STAFF RECOMMENDATION

306 South 15th Street

March 17, 2021

Application: New Construction—Outbuilding; Setback Determination

NOT FOR CONSTRUCTION NOT FOR CONSTRUCTION

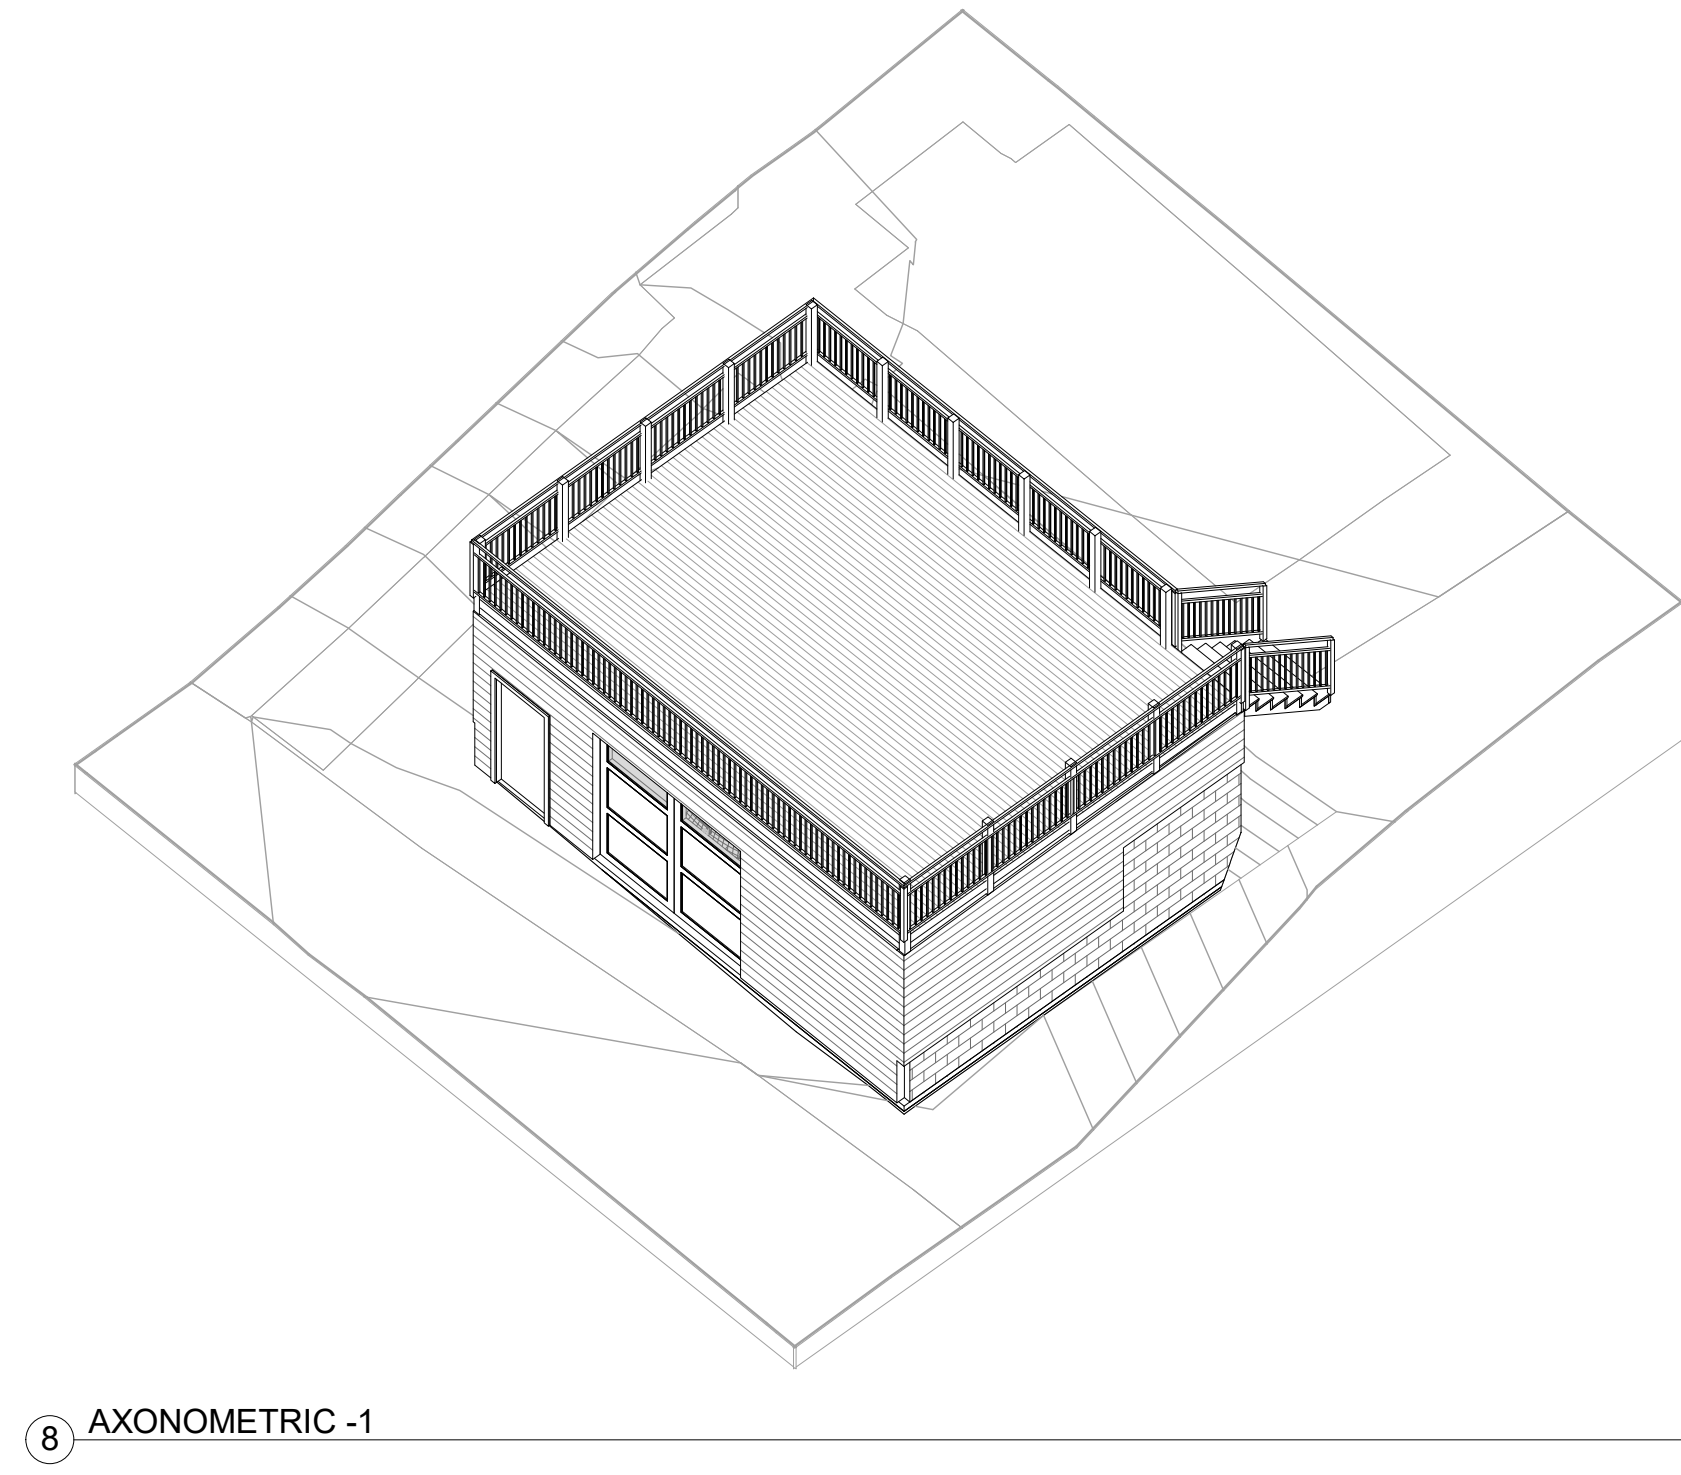
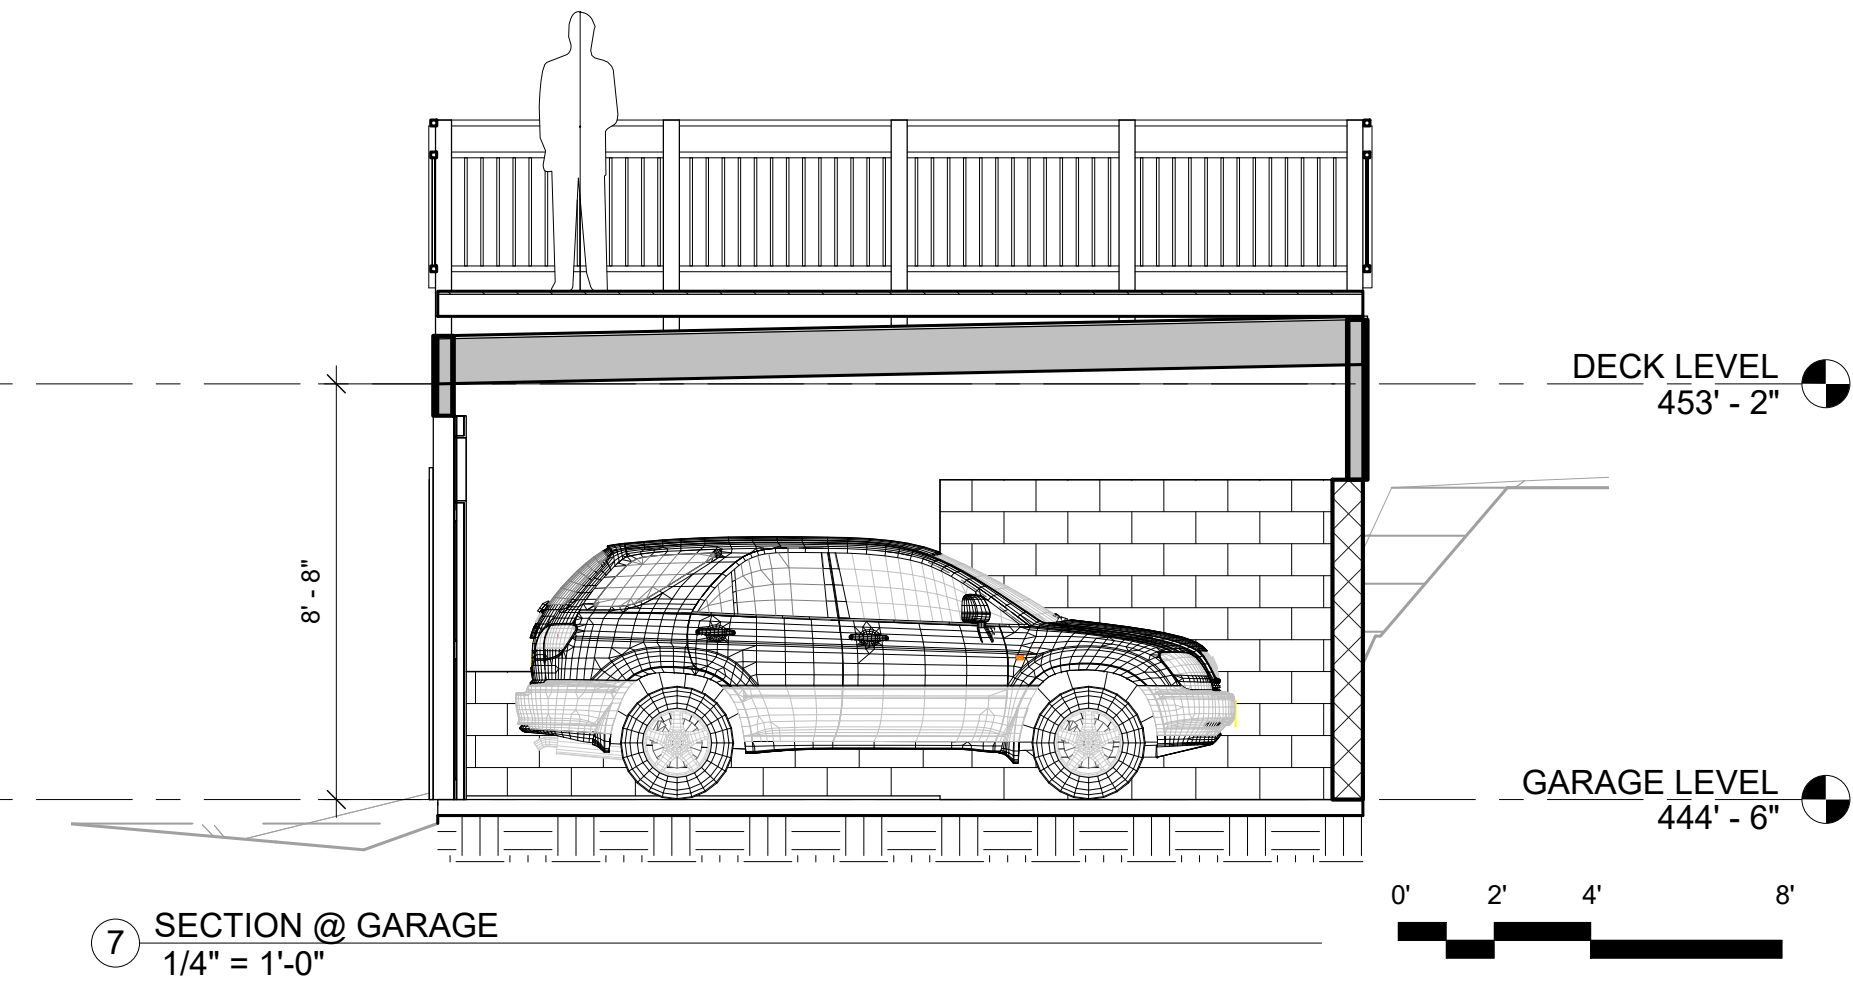
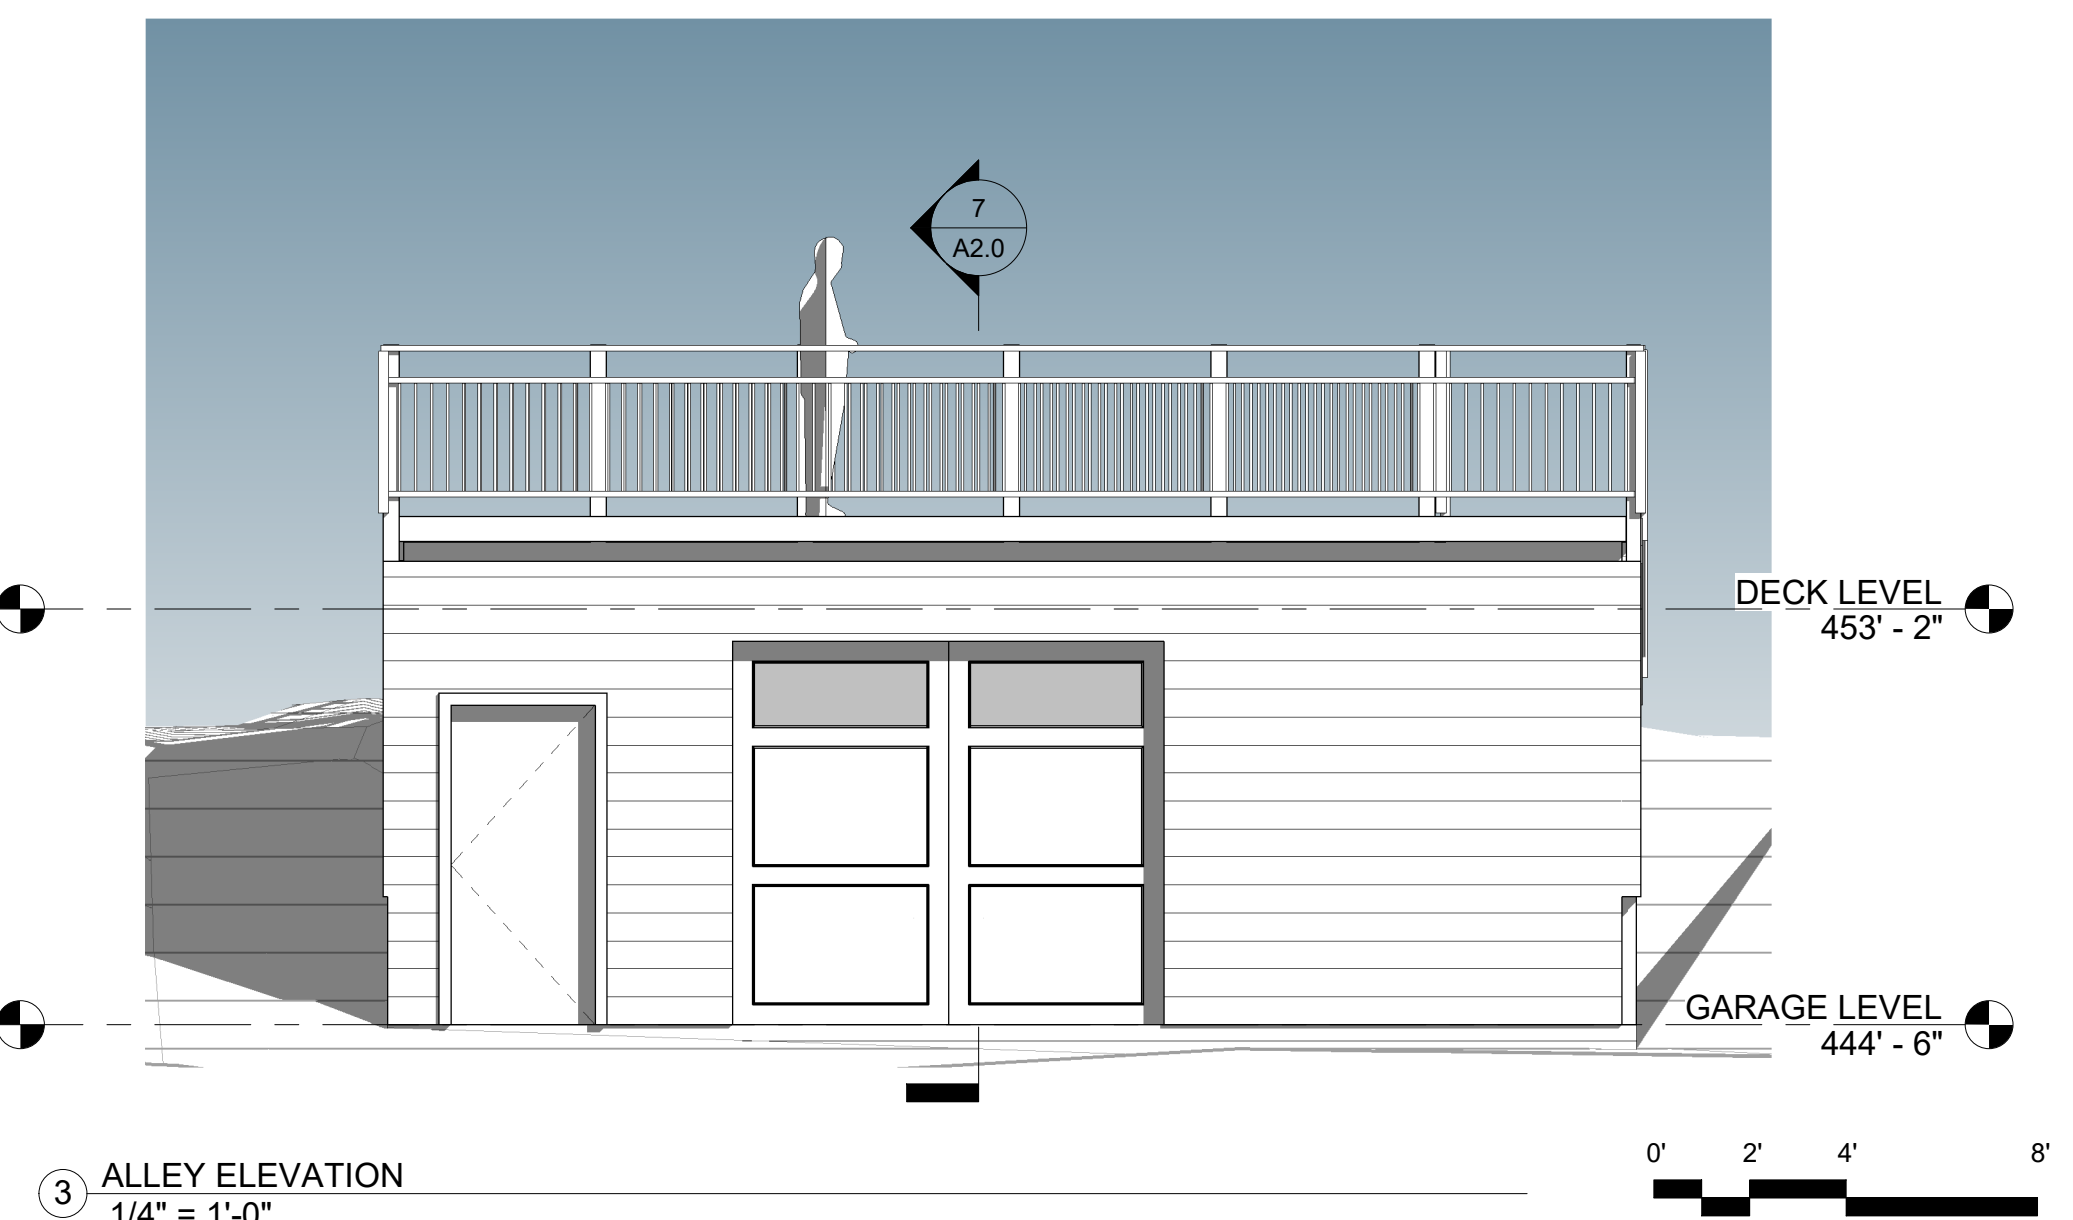
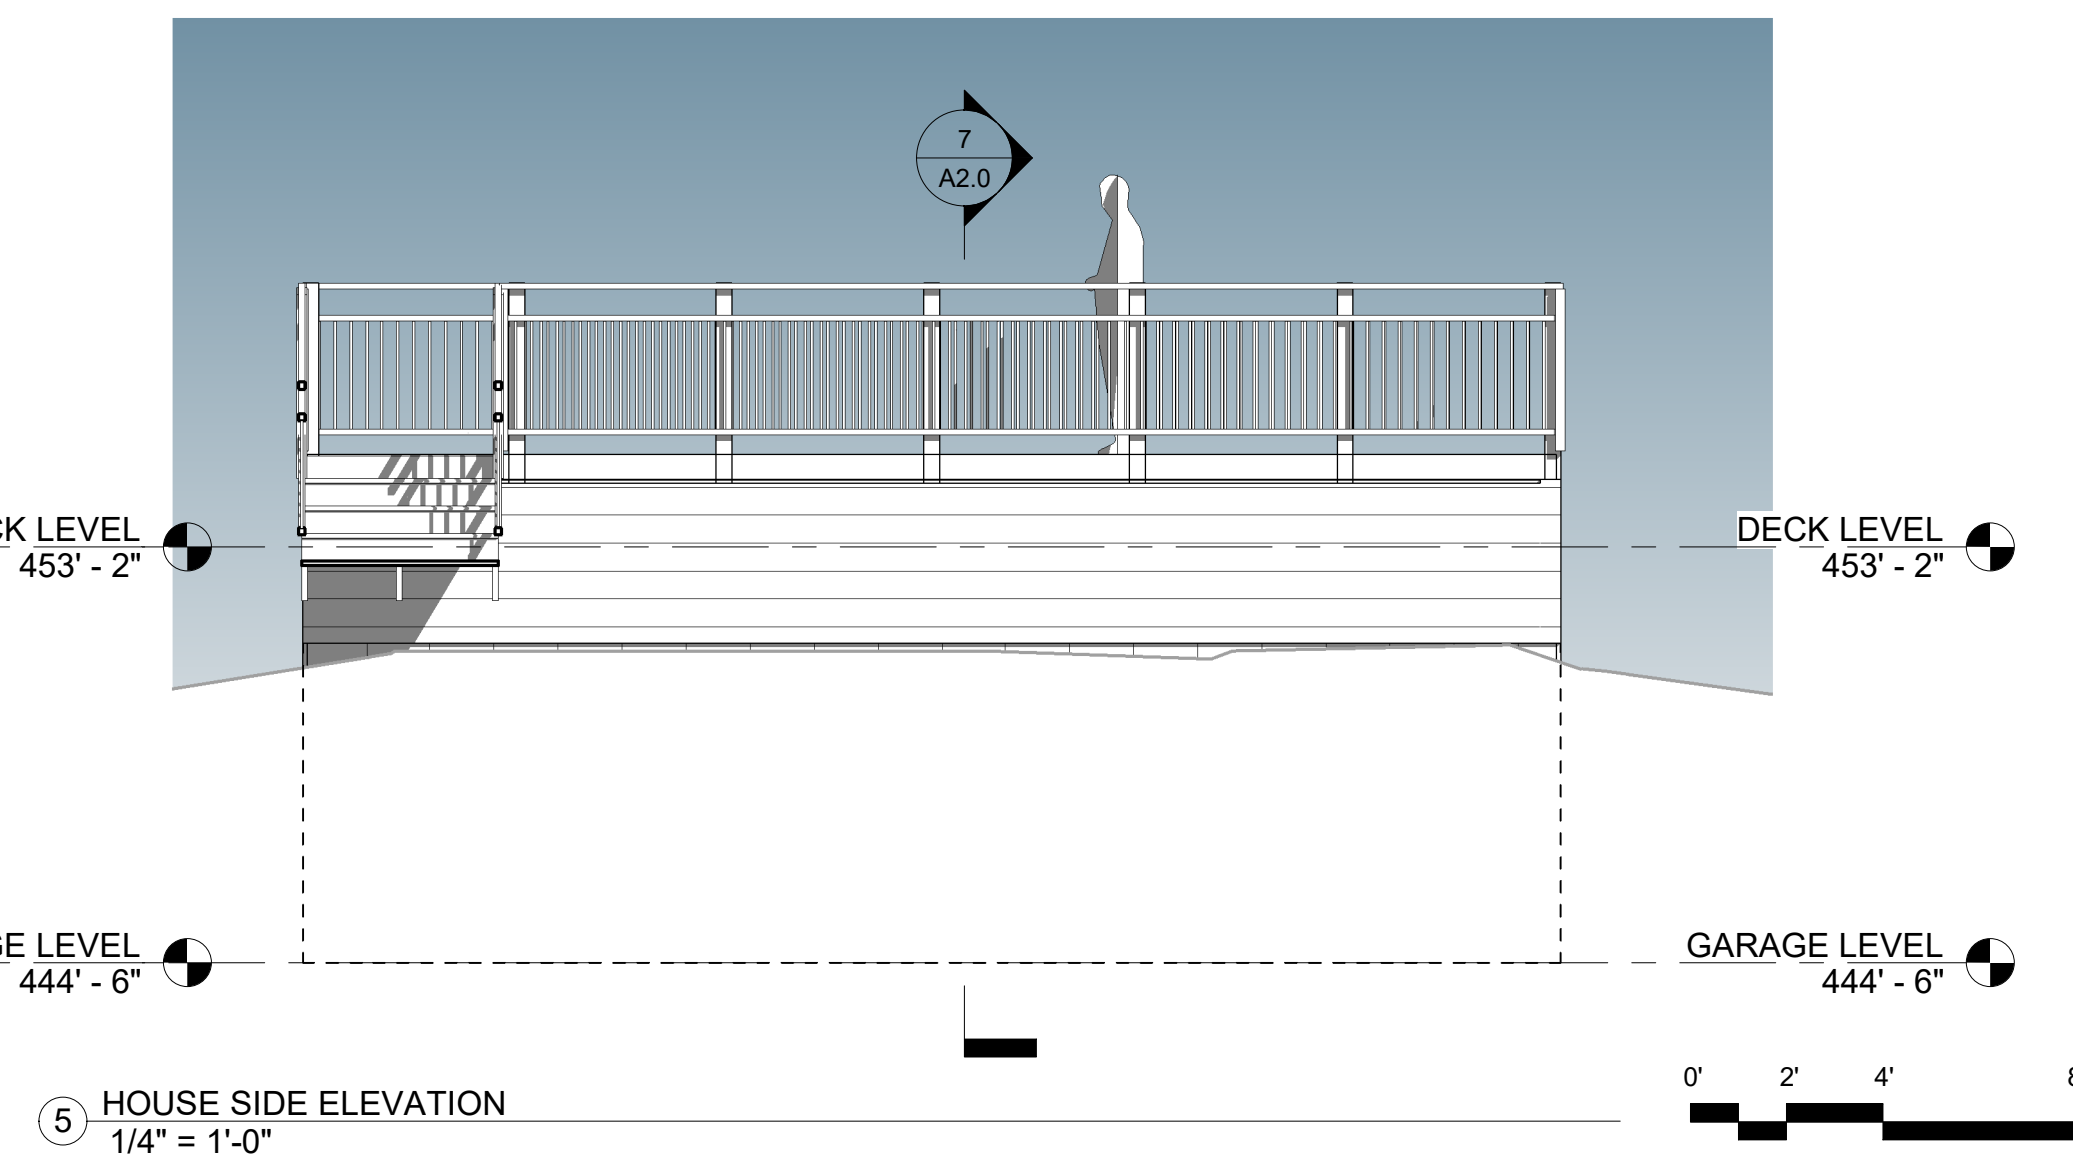
The outbuilding has a flat roof, so both its ridge and eave heights are approximately ten feet (10'). There is a railing that will add another three feet, six inches (3'6") above the roof. Staff find that this railing and its additional height meets the design guidelines because overall, the structure is still lower in height than the historic house.

** The garage has a flat roof rather than a 4/12 or larger roof slope. The Commission has approved flat roofs for outbuildings when the outbuildings are one story in scale and otherwise have an appropriate height and scale, like the proposed. Staff therefore finds that the flat roof meets the design guidelines.

With the condition that the concrete block be split faced and that staff approve the doors, staff finds that the known materials meet Section II.B.8 of the design guidelines.

1. The rear setback be at least five feet (5');
2. The concrete block be split face; and,
3. Staff approve the doors prior to purchase and installation.
